IEC 61850-6

**Communication networks and systems for power utility automation –
Part 6: Configuration description language for communication in power utility
automation systems related to IEDs**

AMENDMENT 1

This Amendment 1 aims to amend the original content of IEC 61850-6:2009 and to correct its content in order ensure a better interoperability of the components implementing it.

Figure 6 – SCL Substation object model

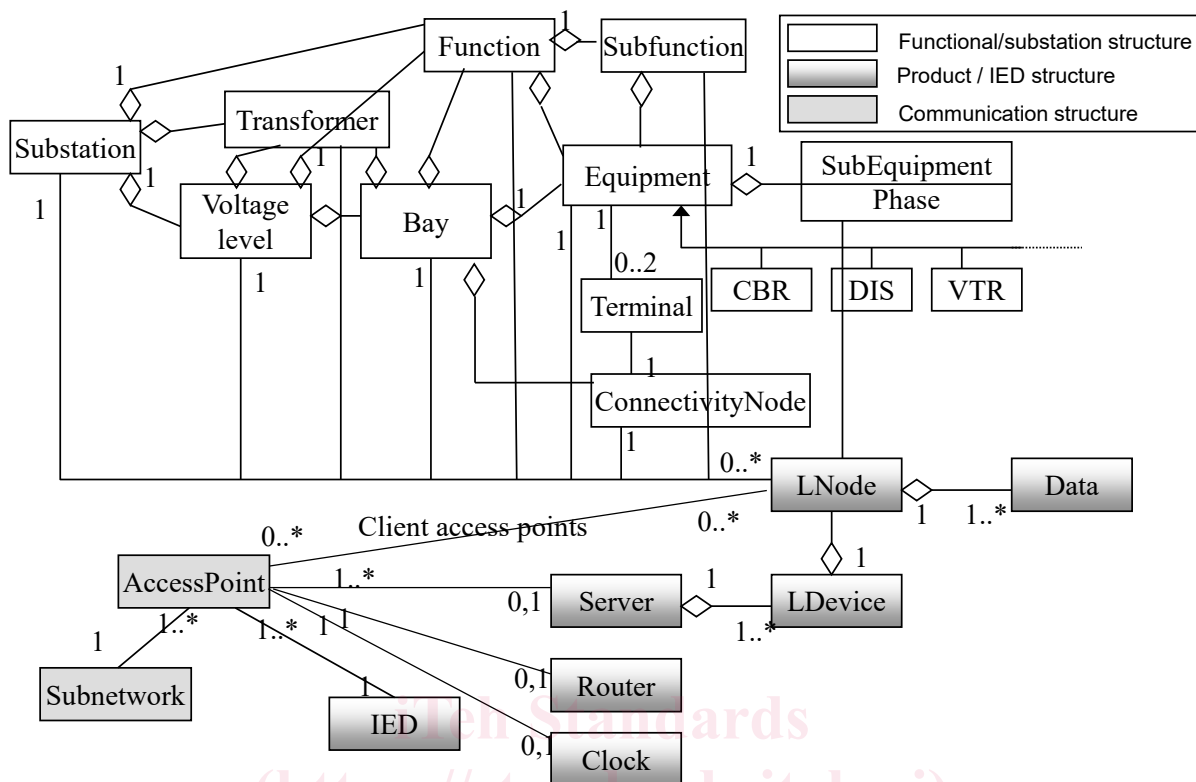
*Replace existing Figure 6 with the following new Figure 6:*

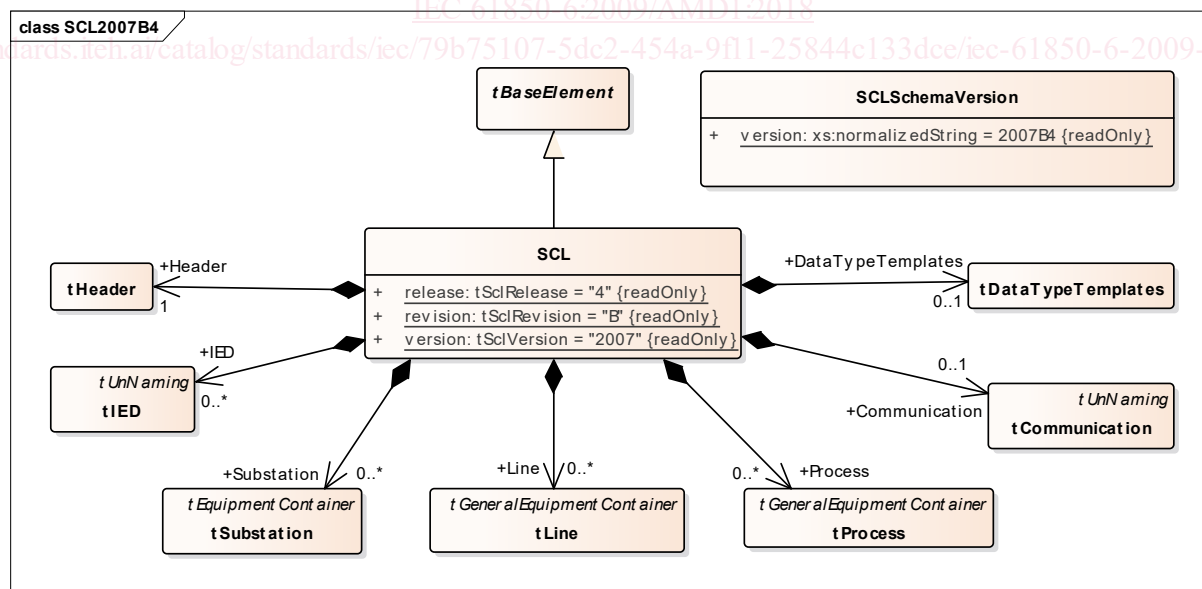
Replace existing Figure 9 by the following new Figure 9:
